OYSTER CREEK NUCLEAR GENERATING STATION, UNIT NO. 1

AMENDMENT TO PROVISIONAL OPERATING LICENSE

Amendment No. 33
License No. DPR-16

ATTACHMENT TO LICENSE AMENDMENT NO. 33

FIGURE 3.10-1

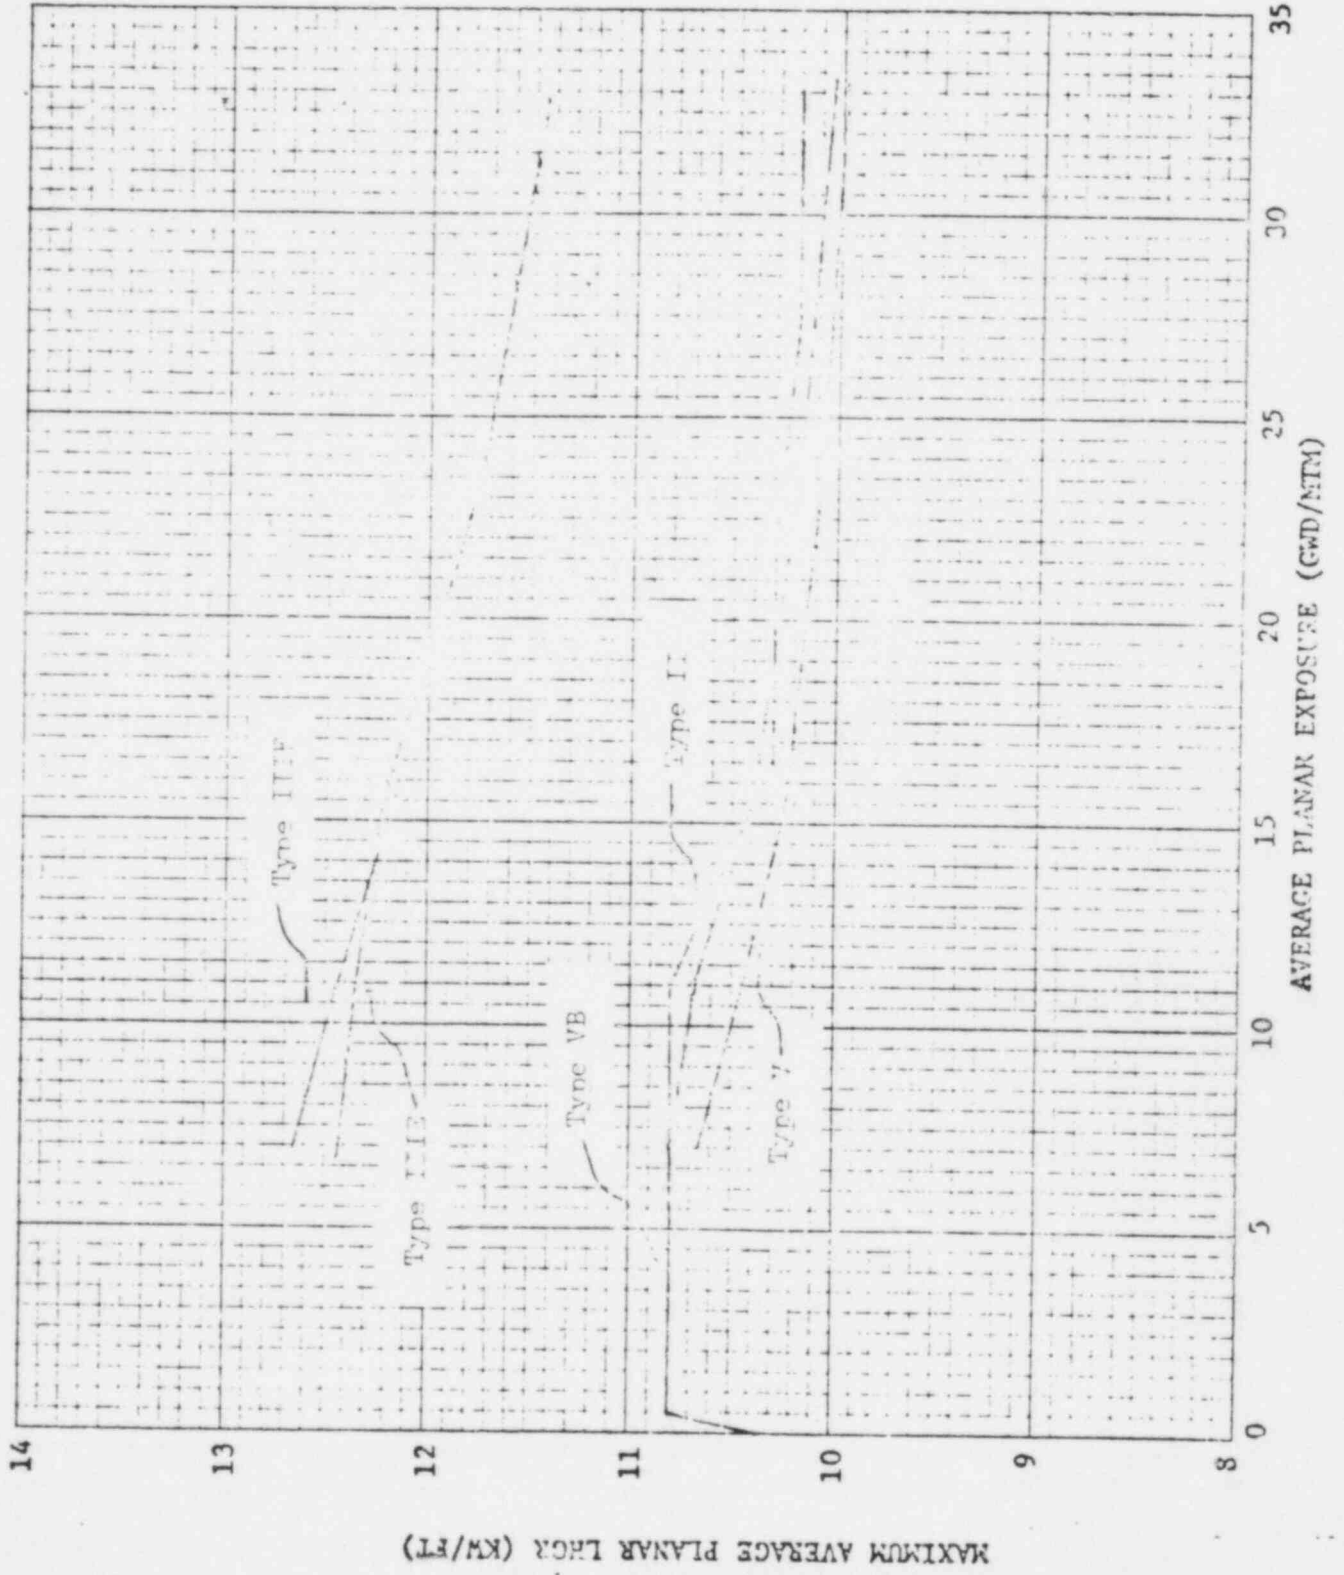
During power operation, the average linear heat generation rate (LHGR) of all the rods in any fuel assembly, as a function of average planar exposure, at any axial location shall not exceed the product of the maximum average planar LHGR (MAPLHGR) limit shown in Figure 3.10-1 and the axial MAPLHGR multiplier in Figure 3.10-2. If at any time during power operation it is determined by normal surveillance that the limiting value for APLHGR is being exceeded, action shall be initiated to restore operation to within the prescribed limits. If the APLHGR is not returned to within the prescribed limits within two (2) hours, action shall be initiated to bring the reactor to the cold shutdown condition within 36 hours. During this period surveillance and corresponding action shall continue until reactor operation is within the prescribed limits at which time power operation may be continued.

The maximum average planar LHGR shown in Figure 3.10-1 for Type II fuel is the result of LOCA analyses performed utilizing an evaluation model developed by General Electric Company in compliance with 10 CFR 50, Appendix K (1). Single failure considerations were based on the revised Oyster Creek Single Failure Analysis submitted to the Staff on July 15, 1975.

The maximum average planar LHGR shown in Figure 3.10-1 for Type IIIE, IIIF, V and VB fuel are the result of LOCA analyses performed by Exxon Nuclear Company utilizing an evaluation model developed by Exxon Nuclear Company in compliance with Appendix K to 10 CFR 50 (2). In addition, the maximum average planar LHGR shown in Figure 3.10-1 for Type V and VB fuel were analyzed with 100% of the spray cooling coefficients specified in Appendix K to 10 CFR Part 50 for 7x7 fuel. These spray heat transfer coefficients were justified in the ENC Spray Cooling Heat Transfer Test Program (3).

FIGURE 3.10-2

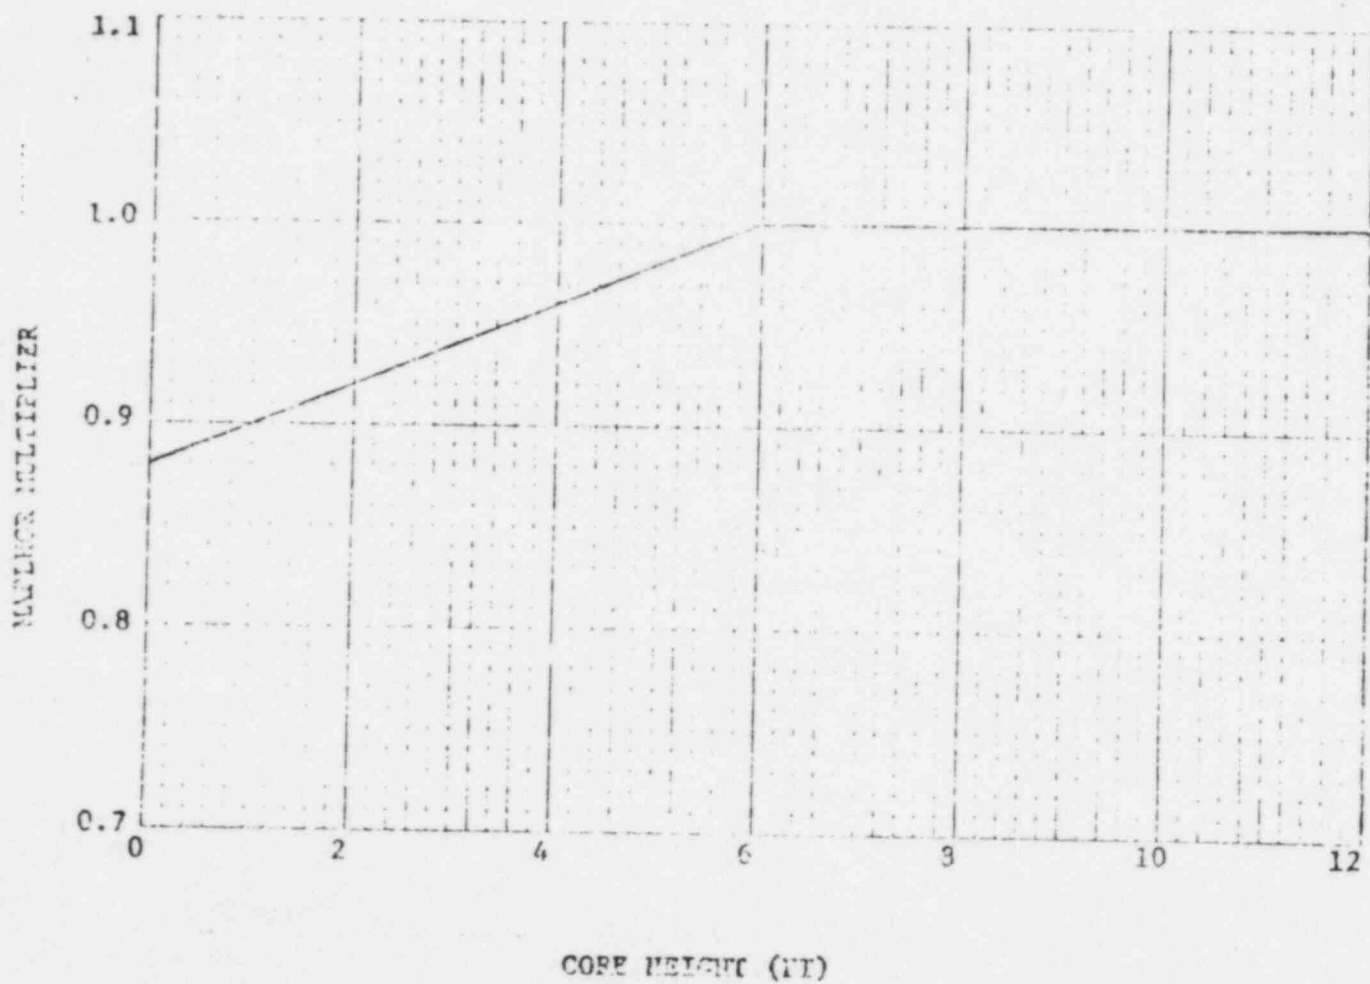
The effect of axial power profile peak location is evaluated for the worst break size by performing a series of fuel heat-up calculations. A set of multipliers is devised to reduce the allowable bottom skewed axial power peaks relative to center or above center peaked profiles. The major factors which lead to the lower MAPLHGR limits with bottom skewed axial power profiles are the change in canister quench time at the axial peak location and a deterioration in heat transfer during the extended downward flow period during blowdown. The MAPLHGR multiplier in Figure 3.10-2 shall only be applied to MAPLHGR determined by the evaluation model described in reference 2.

Note : Applies to fuel types IIIIF, IIIIF, V, and VB.
